Technical Memorandum

To:	Nicholas Simpson, Planning Consultant, Elevate Planning Ltd
From:	Martin Peake, Director, Progressive Transport Solutions Ltd
LUC Number	BUN60460864
Project:	FTAA-2512-1158 Downtown Carpark Site Development
Subject:	Traffic Review
Date:	29 April 2026

Figure 1 - Revised Pedestrian Crossing Arrangement on Lower Hobson Street¹

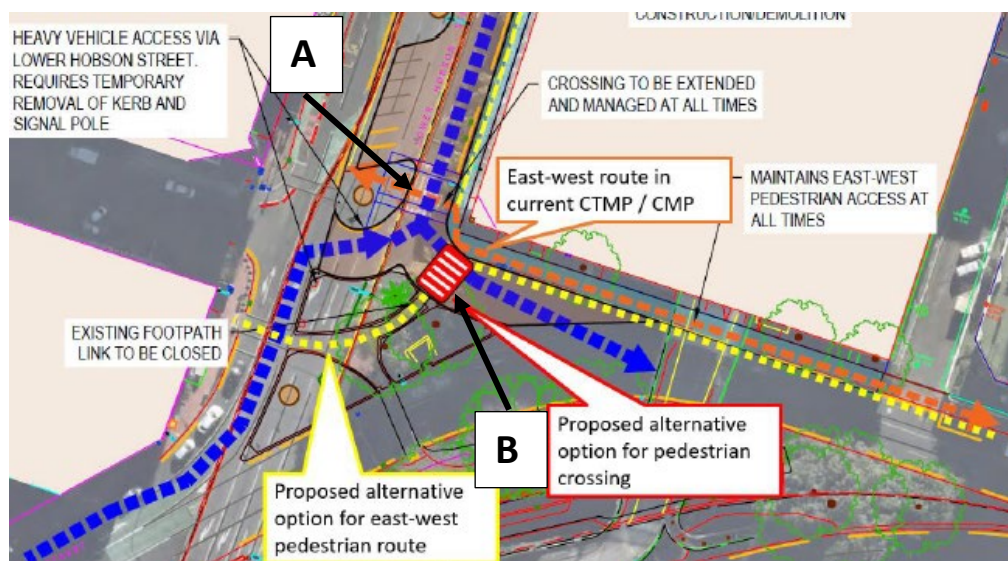
- 4.21 The revised layout amends the pedestrian facilities at the southern end of Lower Hobson Street from that presented and assessed in the Demolition and Construction Transport Assessment. Figure 1 illustrates the amended crossing location with the existing crossing moved from the location marked A to the location marked B.

- 4.22 The intent of the amendment is to reduce the risk of heavy vehicles queuing back onto Sturdee Street should there be pedestrians on the crossing. It is agreed that the amendment would likely reduce the constraint of the crossing on heavy vehicles entering the site directly into Lower Hobson Street, and I consider that the revised arrangement would potentially provide a better facility for pedestrians.

- 4.23 The Demolition and Construction Transport Assessment assessed how trucks such as semi-trailers could access the southbound Lower Hobson Street area for the previously proposed layout. This involved semi-trailers turning from Sturdee Street under the flyover into eastbound Customs Street West into the area marked B in Figure 1 and then reversing back into Lower Hobson Street. In addition, a loading bay was proposed on the northern side of Customs Street West at location B. The revised layout would impact on this proposed method of operation. Therefore, an updated assessment is required of the revised configuration to demonstrate how these semi-trailers would access the site and/or trucks will be able to exit the site forwards.
